# SHORE POINT ARCHITECTURE, PA

Re: Response to (Undated) HPC Technical Review Letter  
120 Franklin Ave, Ocean Grove (Warren Residence)  
SPA Job Number: 2025-03

## WROUGHT IRON GATE DETAIL

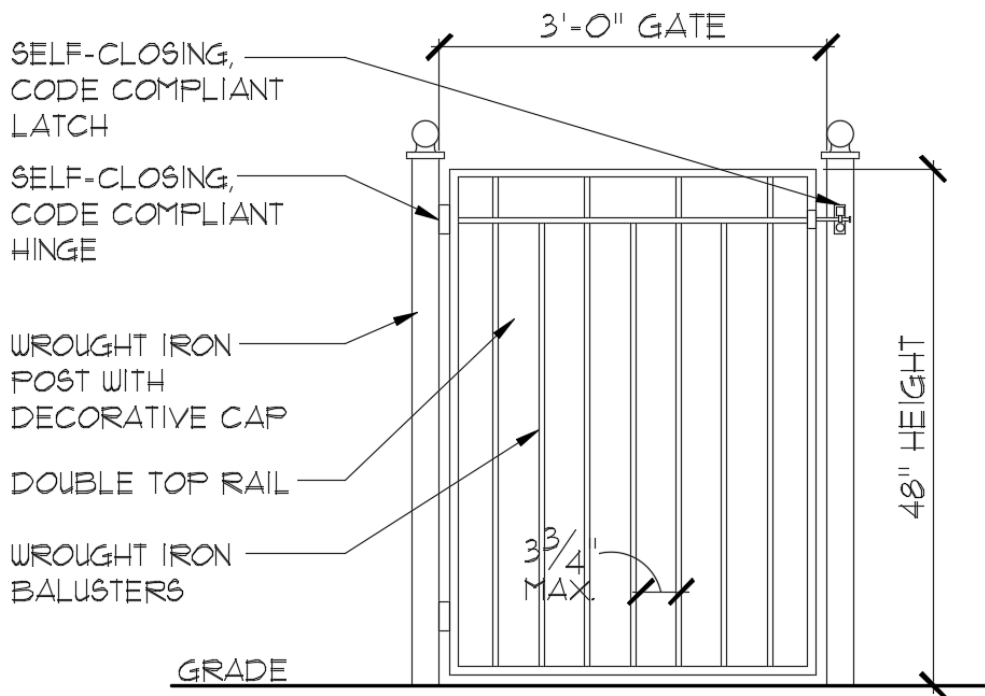
## **B) Wrought Iron Fence Gate Detail**

While a detail of the wrought iron fence was included in our submission, we understand that a separate detail for the gate is required. Please find enclosed a drawing of the gate detail for your review. We confirm that no additional gates, walkways, paths, or steps are proposed beyond those shown on the submitted site plan. Specifically, there is no proposed access from Stockton Avenue.
